Plant Operations Relocation  
Amended Site Plan Review Narrative  
05.12.14 rev.

Saint Leo University  
Plant Operations Relocation Landscape Buffer  
Variance Justification Statement

Re: St. Leo University  
Lincks Project No. 14084

- Peer Review of Plant Operations Building Traffic Impact Study
- Truck Turn Evaluation
- Pavement Evaluation
- SR 52 and Pompanic Street Intersection Assessment
- Pompanic Street and Project Access Assessment

FIGURE 1

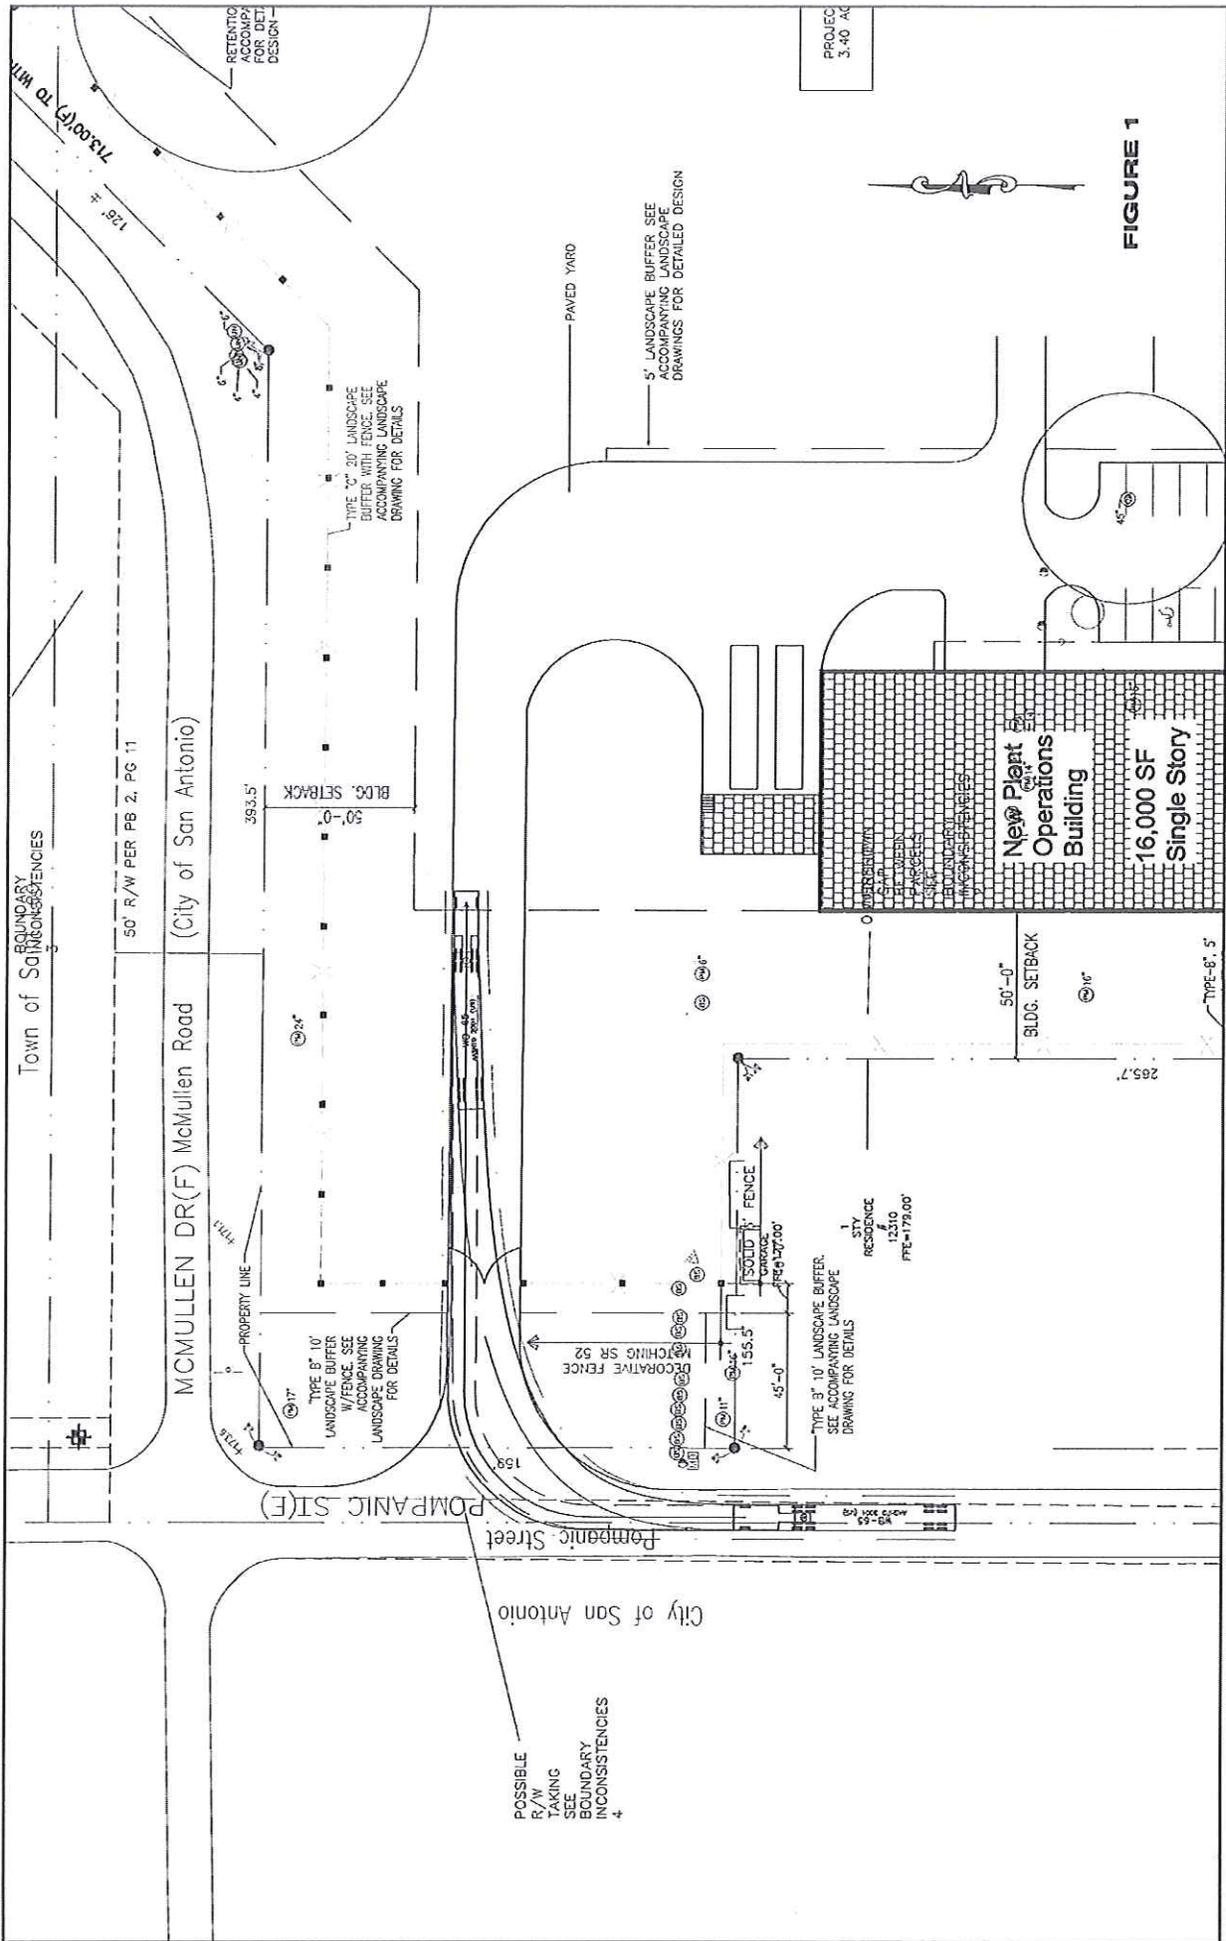
Figures 1 and 2 provide the truck turns into and out of the proposed project access. It is our understanding the University and Town of St. Leo are to widen Pompanic Street to 24 feet. With the widening of the roadway and the accesses as shown, the trucks should be able to access the facility without off tracking. The access could be designed with the existing roadways to accommodate the trucks without off tracking. However, with eighteen (18) feet it would be difficult for two-way traffic along the roadway with large trucks.
